MEADOW OAKS ADDITION

Re: S/D 93-27 MEADOW OAKS ADDITION (Final Plat)

**STAFF REPORT**  
(Final Plat Approved 5/13/93)

**CASE NUMBER:** S/D 93-27 - MEADOW OAKS ADDITION

# MEADOW OAKS ADDITION

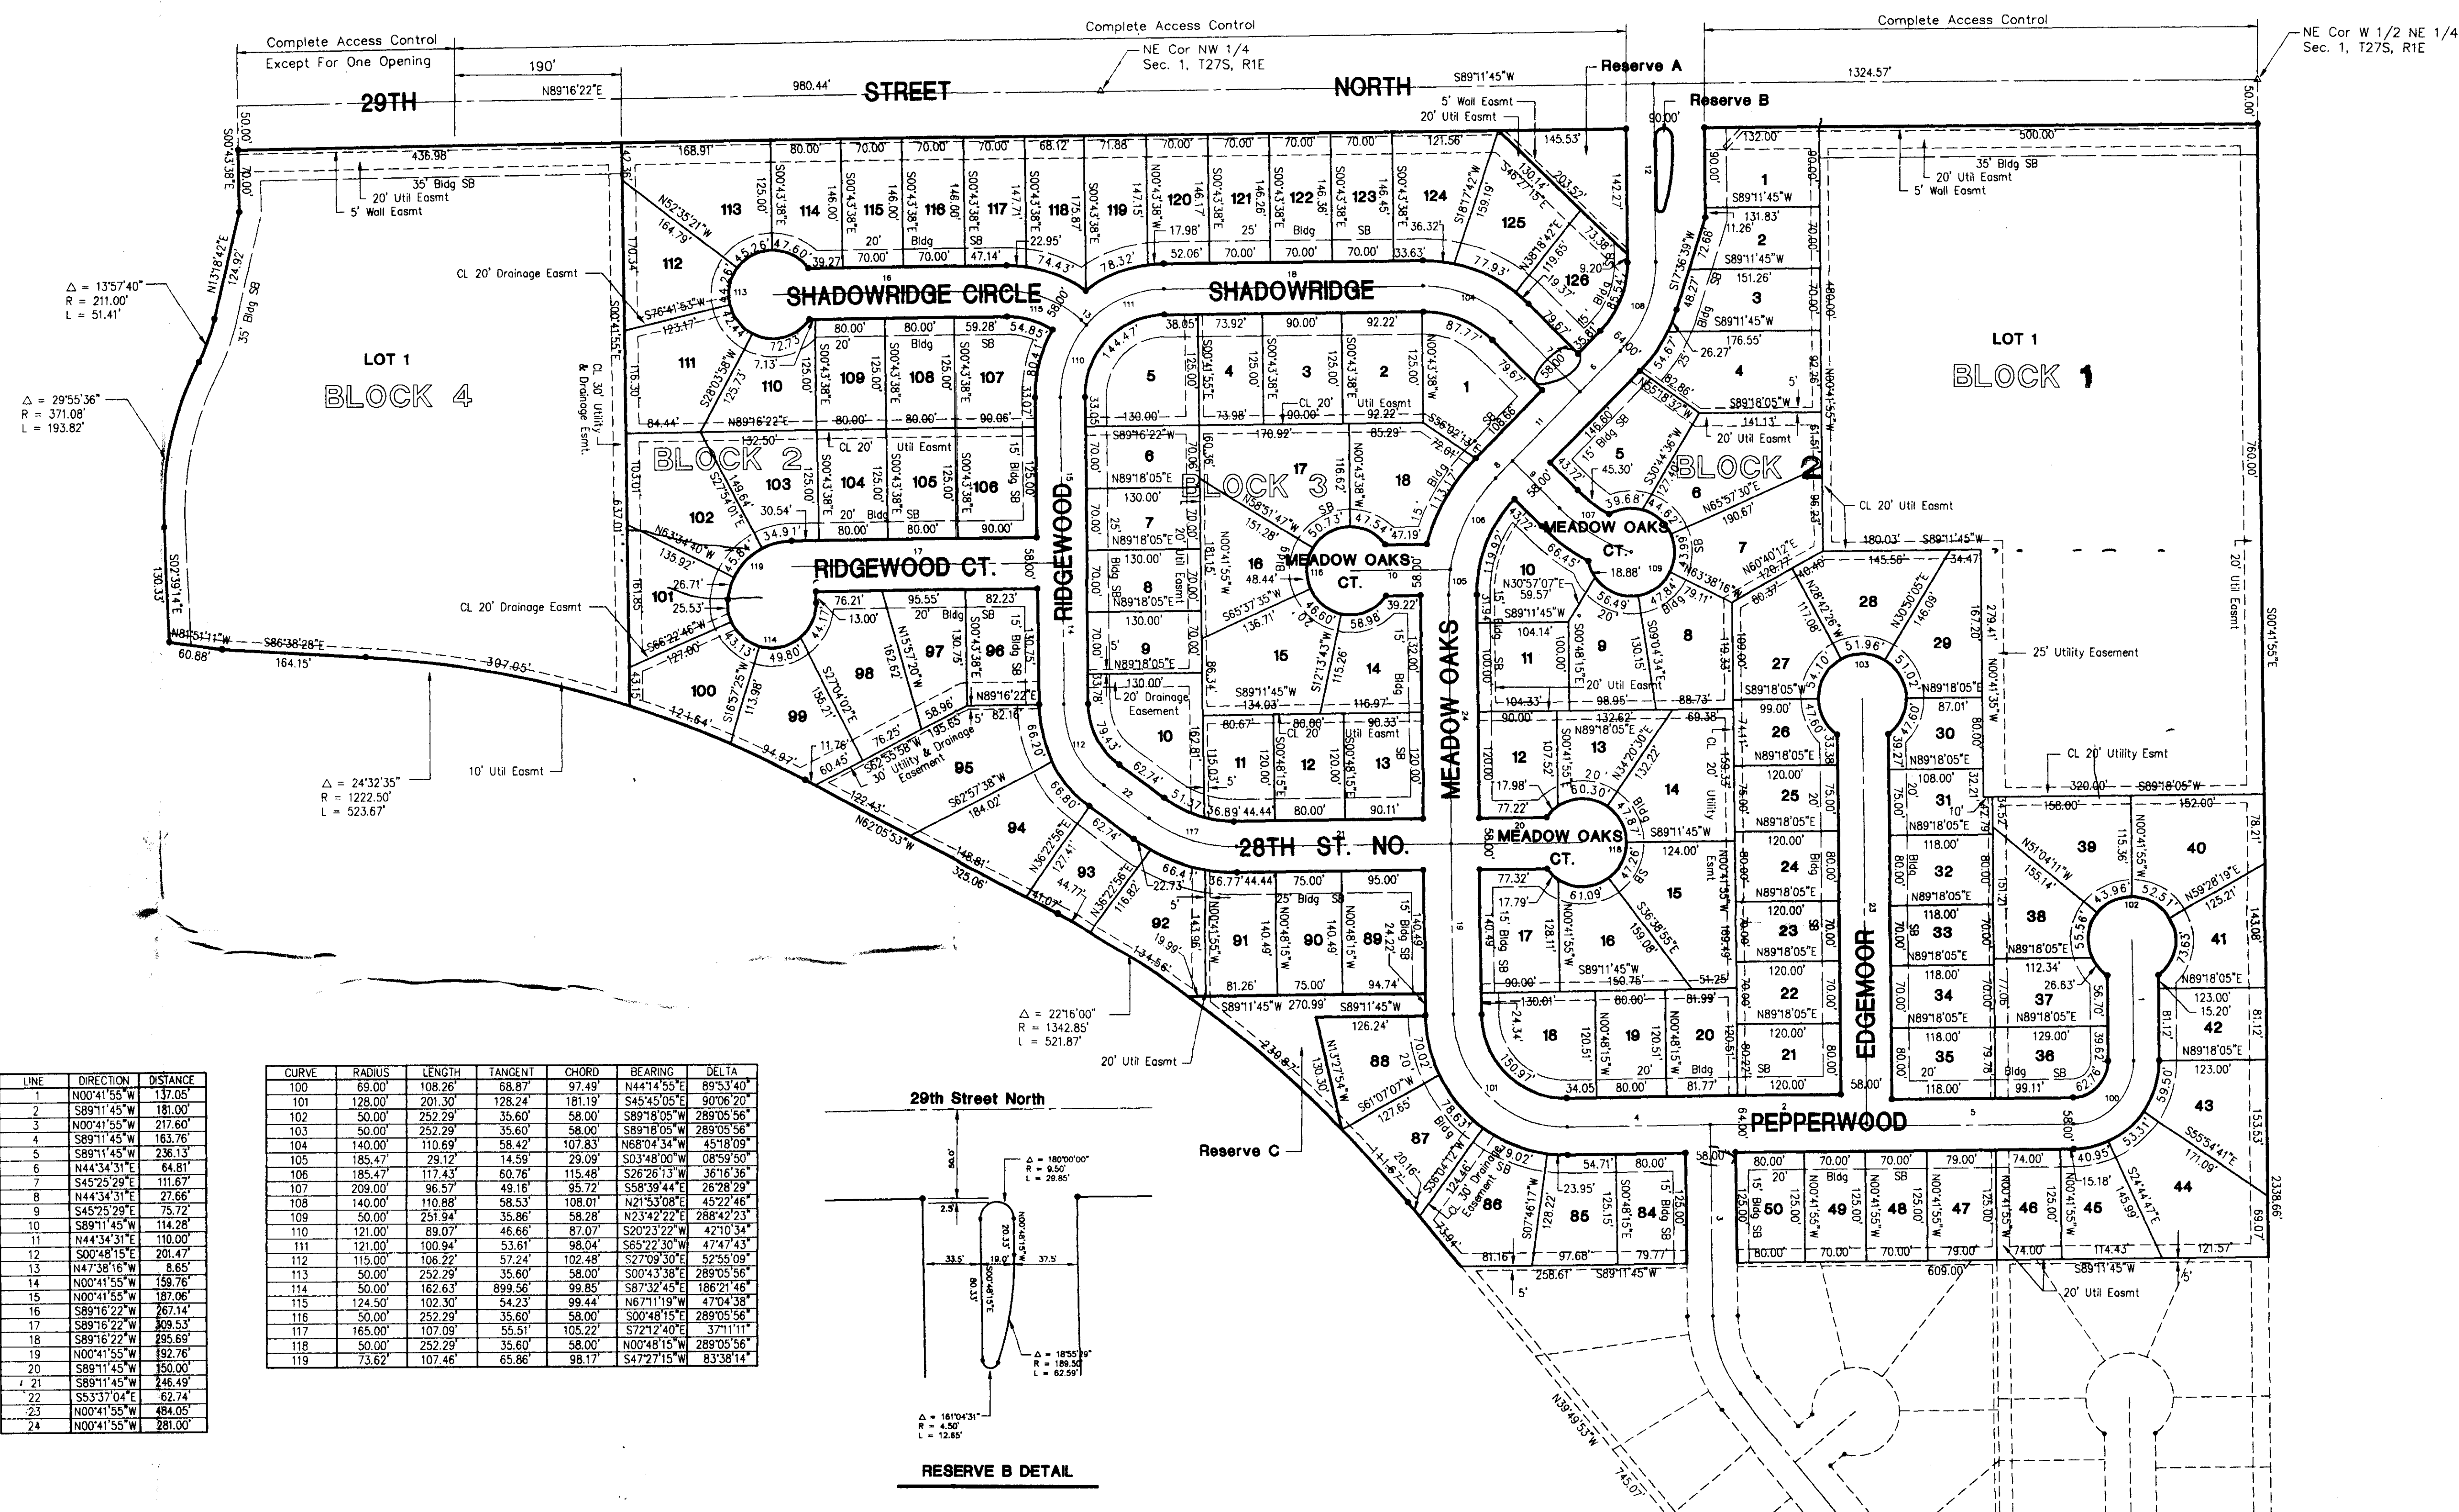
- T. On the final plat tracing, the word Block and the associated numbers shall be more boldly or distinctly indicated.
- U. In terms of street names, the suffix Circle should be used in the following cases; Pepperwood east of Edgemoor and Edgemoor north of Pepperwood. The following street name changes shall also be made: Ridgewood Ct. to Parkwood Ct. and Charlotte to Meadow Oaks Ct.

- V. On the final plat tracing, the Mayor's signature block shall be amended to indicate Elma Broadfoot as Mayor.
- W. The final plat shall indicate the utility easements requested by K.G. & E. which are indicated on the enclosed "marked" copy of the plat.

- AA. Perimeter closure computations shall be submitted with the final plat tracing. Section 5-101(c).
- BB. Recording of the plat within 30 days after approval by the City Council.

- DD. On the final plat tracing, minimum building pad elevations shall be established for lots adjacent to the drainageway along this plat's south line. These minimum pad elevations shall be shown on the face of the plat and referenced in the plat's text. It shall be indicated if these elevations are for the lowest opening or level. Both on-site and off-site benchmarks shall also be indicated.

- A. The applicant shall guarantee the extension of sanitary sewer to serve the lots being platted.
- B. The applicant shall guarantee the extension of City water to serve the lots being platted.

- C. The applicant shall guarantee the paving of the proposed interior streets.
- D. The applicant shall guarantee any drainage improvements required by the platting of this property.

- E. The applicant shall guarantee construction of the storm sewers required by this plat.
- F. As indicated by General Provision 18 of DP-147, the applicant shall guarantee a decel lane in 29th Street North for the major entrance into this Addition, at Meadow Oaks. Traffic Engineering needs to indicate if any additional traffic improvements need to be guaranteed.

- G. As indicated by a sidewalk plan, approved for this area by the Subdivision Committee in 1986, and based upon General Provision 11 of DP-147, a sidewalk system is to be provided across this site. Specifically, sidewalk is to be guaranteed along one side of Meadow Oaks (west) from 29th Street southward to Pepperwood. This sidewalk is then to continue westward through Reserve C and cross the adjacent drainage channel, and eastward along Pepperwood (south side) until in the vicinity of Lots 41, 42, or 43, it was to enter a pedestrian access easement between two of these lots so as to extend to the east line of the plat. Guarantees for this sidewalk system may be part of the paving petition.

In order to accommodate the above sidewalk, a pedestrian easement needs to be granted and shown somewhere in the vicinity of Lots 41, 42, and 43, Block 2 and the platting text shall note the granting of such an easement. Required covenants for this Addition shall also indicate that the Addition's homeowners' association will be responsible for maintaining the sidewalk in this easement.

- H. Both on the CUP and the approved plat the streets now being indicated as Shadowridge/Ridgewood/28th Street North were indicated as being platted with a 64-foot right-of-way. Based on the number of lots directly and indirectly accessing these streets, the present Subdivision Regulations would also require that these streets be platted at the 64-foot standard. The final plat shall therefore indicate these streets at the 64-foot right-of-way standard.

- I. Unless a cemetery is intended for Lot 1, Block 1, an amendment to the CUP will be needed to allow any such use as a church or apartments at this location. Further, no access is shown to this site except what would be allowed from 29th street North. However, this plat and the CUP are both indicating complete access control to 29th Street North across this lot's north property line. Assuming that the applicant does desire access to this lot from 29th Street North, the applicant will need to amend the CUP to allow for such access and the final plat shall also reflect such an access request. That is, the face of the plat and the plat's text will need to indicate the access being allowed to this lot.

- J. Because of the single point of entrance into this site, from 29th Street North, both the CUP and Preliminary Plat indicated a 20-foot wide emergency access easement entering this site from 29th Street North, at the northeast corner of the Addition. However, that area was originally indicated as most likely being platted with single family lots, with an interior street within a short distance of 29th Street North. This plat is now showing one large lot at that location and no nearby interior street.

The need for such an emergency access easement is, though, still as great. Such an easement shall therefore be provided somewhere in the area of Lots 113 through 115, Block 2, running from 29th street North to Shadowridge Circle. The plat's text shall also reference this easement and covenants shall be provided indicating that the homeowners association will be responsible for maintaining this access easement. As indicated in the Subdivision Regulations, the applicant shall submit any needed guarantee for the installation of a driving surface, gates, fences, etc. required for such an easement.

If, however, as indicated by the applicant, the western portion of Block 2 and all of Block 4 is to be replatted into one-family lots with Ridgewood (Parkwood) extending westward to Beacon Hill, the above indicated easement may be created as a temporary easement and by separate document. This separate document shall note that the access easement will take effect and become permanent and be installed, if and when 60 or more lots in this addition are developed, provided however, that if the above replatting and extension of Ridgewood (Parkwood) does occur prior to that time, that such easement is no longer needed and automatically shall terminate. Such temporary easement needs to be submitted to Planning for review and subsequently recorded by the applicant with the recording information shown on the final plat tracing.

- K. Provisions shall be made for ownership and maintenance of the proposed reserves. The applicant shall either form a lot owners' association prior to recording the plat or shall submit a covenant stating when the association will be formed, when the reserves will be deeded to the association and who is to own and

maintain the reserves prior to the association taking over those responsibilities. This covenant shall also provide that the homeowners association will be responsible for maintaining the "parking strip" or open space area between this site's north property line and the paved surface of 29th Street North. Also, the previously noted requirements for a pedestrian or sidewalk easement and the emergency access easement may be provided for in this covenant.

- L. For those reserves being platted for drainage purposes, the required covenant which provides for ownership and maintenance of the reserves shall grant, to the City, the authority to maintain the drainage reserves in the event the owner(s) fail to do so. The covenant shall provide for the cost of such maintenance to be charged back to the owner(s) by a method similar to special assessments.

- M. The applicant shall submit a covenant which provides for four (4) off-street parking spaces per dwelling unit on each lot which abuts a 58-foot street. The covenant shall inventory the affected lots by lot and block number and shall state that the covenant runs with the land and is binding on future owners and assigns.

- N. On the final plat tracing since an opening is being indicated to 29th Street from a portion of Lot 1, Block 4, the word "complete" shall be deleted from the face of the plat. This access should also be noted in the plat's text. As now written, the text indicates that all lots have complete access control to 29th Street.

- O. On the final plat tracing, Beacon Hill adjacent to the west line of Lot 1, Block 4 shall be indicated. The center line of this street shall be labeled, with street right-of-way also indicated.

- P. On the final plat tracing, and as indicated by the CUP, 25-foot building setbacks were to be indicated for the frontages of all lots adjacent to streets with 64-foot rights-of-way. This includes the 64-foot streets requested above; also any 64-foot streets already shown on this plat, such as Pepperwood. Corner lots may indicate a 15-foot building setback for the intended sideyard.

- Q. Since Reserves A and B are indicated as being platted for structures, a 25-foot building setback shall be indicated to 29th Street North. Reserve A shall also indicate a sideyard setback to Meadow Oaks.

- R. The applicant is advised that the guardhouse being indicated for Reserve B cannot be used in any way to inhibit public access into or out of this Addition. That is, Meadow Oaks is being platted as a public street and such access cannot be interfered with.

- S. On the final plat tracing, the centerline of 29th Street North shall be labeled (CL).
